TVA-BFN-TS-414 Supplement 2

**BROWNS FERRY NUCLEAR PLANT (BFN) - REDUCTION IN REQUESTED
EFFECTIVE FULL POWER YEARS (EFPY) FOR TECHNICAL
SPECIFICATIONS (TS) CHANGE NO. 414 - PRESSURE - TEMPERATURE
(P-T) CURVE UPDATE**

PROPOSED TECHNICAL SPECIFICATION (TS) CHANGE TS-414 SUPPLEMENT
2

**Figure 3.4.9-1
Pressure/Temperature Limits**

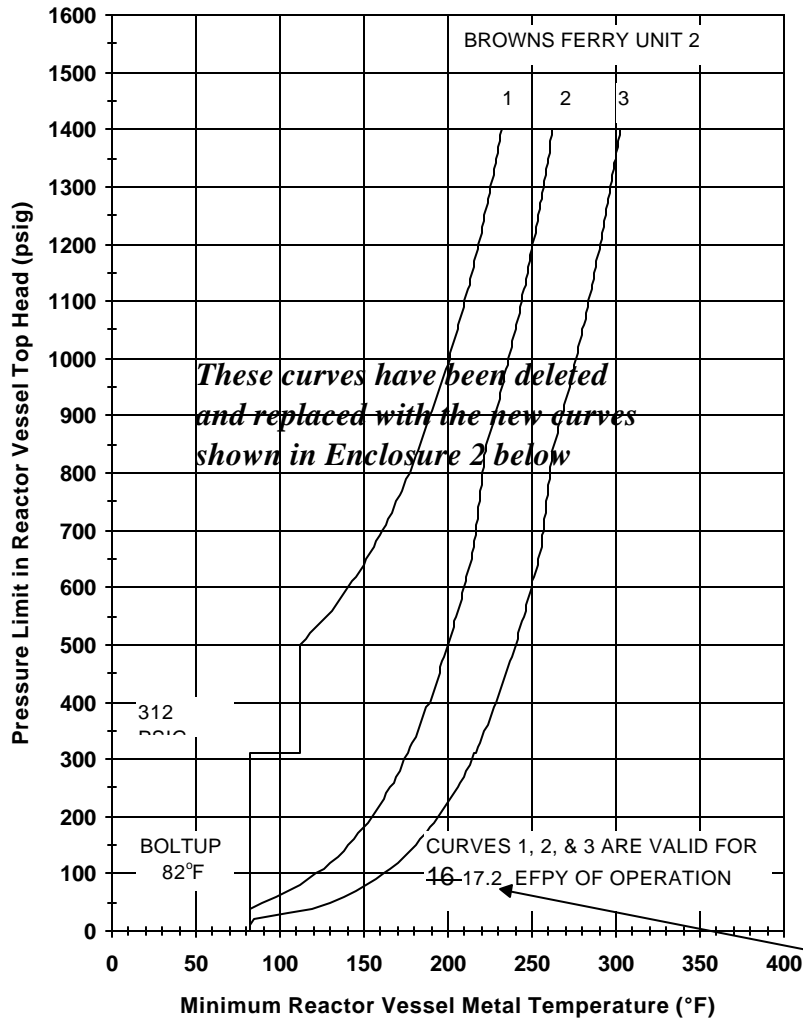
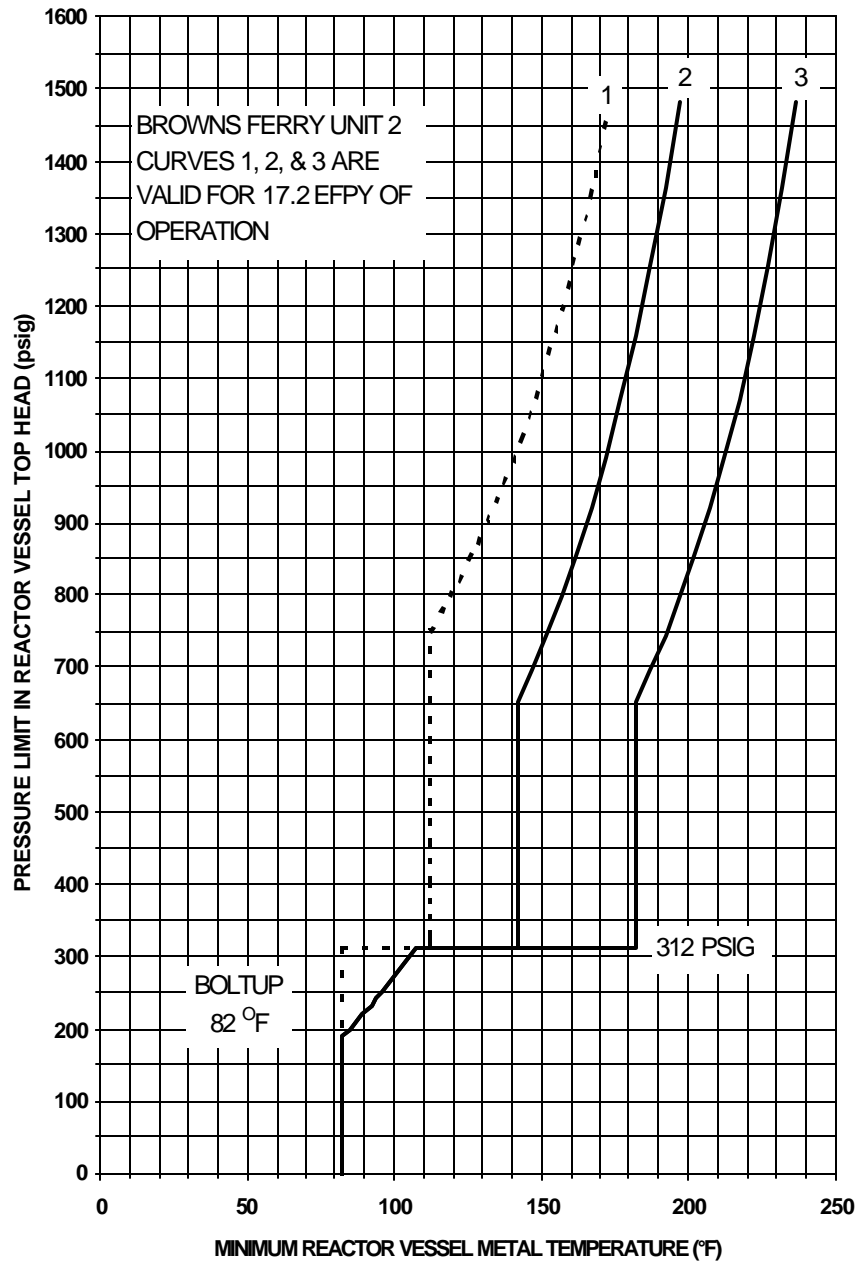
Added "ASME" for additional
clarity in this note.

Notes
These curves include sufficient margin to provide protection against feedwater nozzle degradation. The curves allow for shifts in RT_{NDT} of the Reactor vessel beltline materials, in accordance with Reg. Guide 1.99, Rev. 2, to compensate for radiation embrittlement for 16-17.2 EFPY.

The period of valid use of these curves has been changed from 16 to 17.2 EFPY.

These curves include sufficient margin to provide protection against feedwater nozzle degradation. The curves allow for shifts in RT_{NDT} of the Reactor vessel beltline materials, in accordance with Reg. Guide 1.99, Rev. 2, to compensate for radiation embrittlement for 17.2 EFPY.

**Figure 3.4.9-1
Pressure/Temperature Limits**

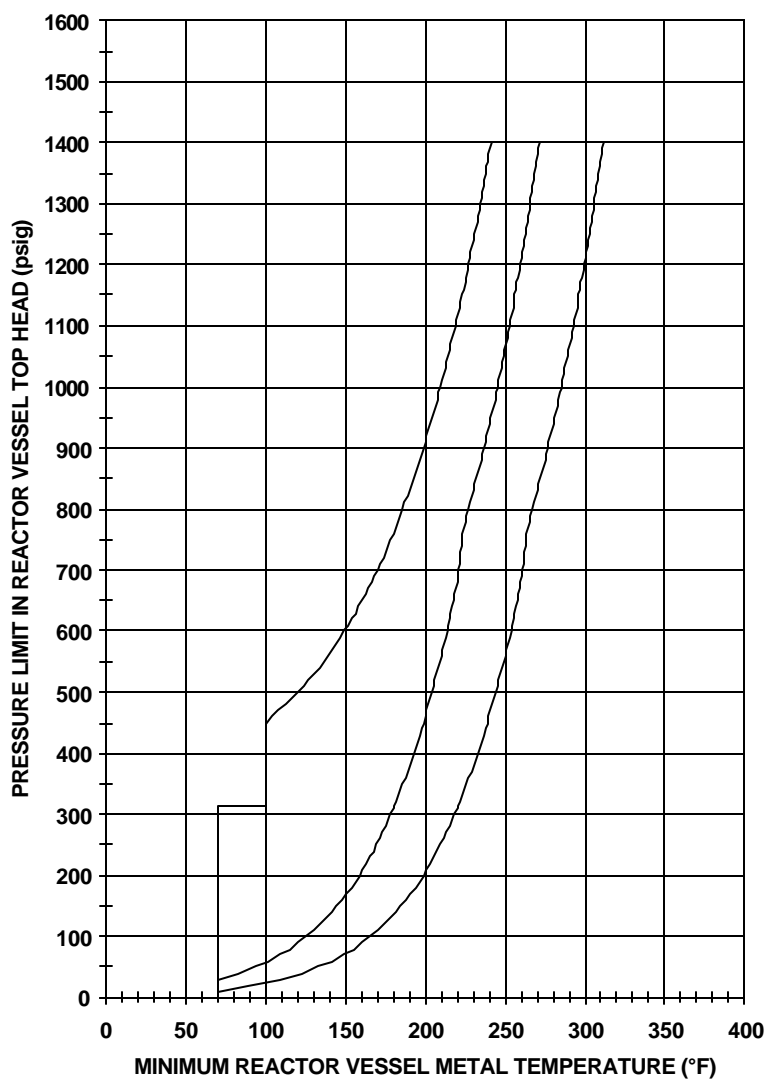
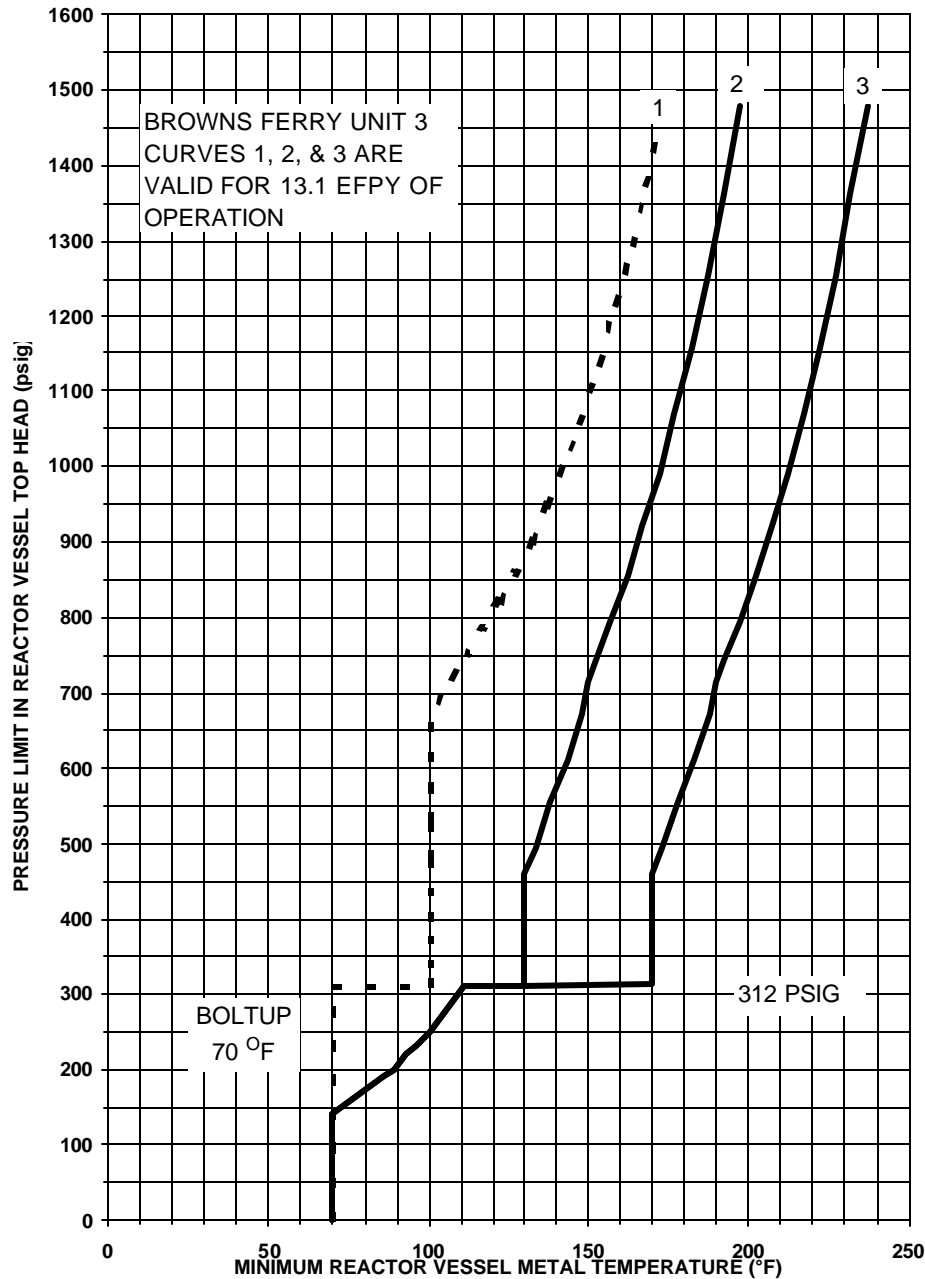
Added "ASME" for additional clarity in this note.

These curves include sufficient margin to provide protection against feedwater nozzle degradation. The curves allow for shifts in RT_{NDT} of the Reactor vessel beltline materials, in accordance with Reg. Guide 1.99, Rev. 2, to compensate for radiation embrittlement for 20 13.1 EFPY.

These curves have been deleted and replaced with the new curves shown in Enclosure 2 below

CURVES 1, 2 & 3 ARE VALID
FOR 20 13.1 EFPY OF
OPERATION

The period of valid use of these curves has been changed from 20 to 13.1 EFPY.

These curves include sufficient margin to provide protection against feedwater nozzle degradation. The curves allow for shifts in RT_{NDT} of the Reactor vessel beltline materials, in accordance with Reg. Guide 1.99, Rev. 2, to compensate for radiation embrittlement for 13.1 EFPY.
